**Argyll and Bute Council**  
**CHORD Programme**  
**Assessment of Proposals for Short Stay Yacht Berthing Facility in Oban Bay**

**Figure 1 – Cash Flow Analysis**

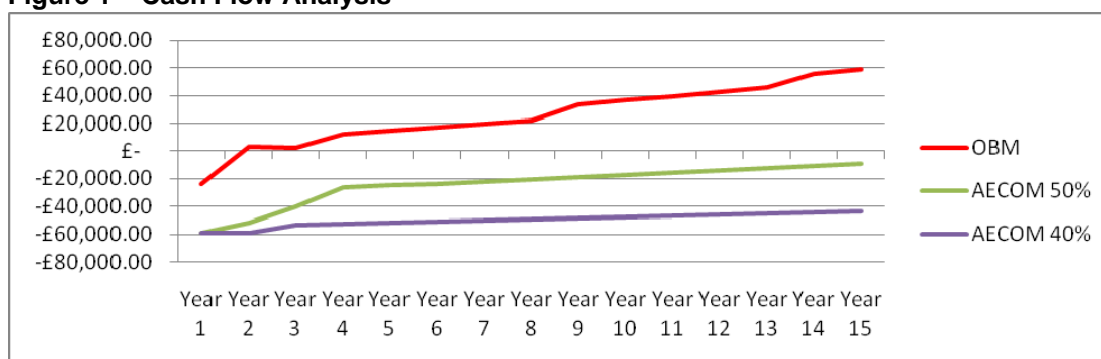
A cash flow analysis for a) OBM forecast, b) AECOM 50% and c) AECOM 40% have been prepared, and are presented in chart form in Figure 1, below. All the scenarios presented below assume that capital funding gap is provided as a grant, free of charge to the project.

Whilst OBM's forecast demonstrates a positive cash-flow projection, the forecasts developed by AECOM, and confirmed by TRC's analysis, demonstrate yearly losses. The more conservative assumption of 40% occupancy implies worsened performance, and increased annual losses.

The potential addition of up to £18,000 additional income which was indicated by OBM, but not included within their cash flow (advertising, RIBS, fuel) does not materially affect the 40% scenario, but implies a break even at around year 9 for the 50% occupancy scenario.
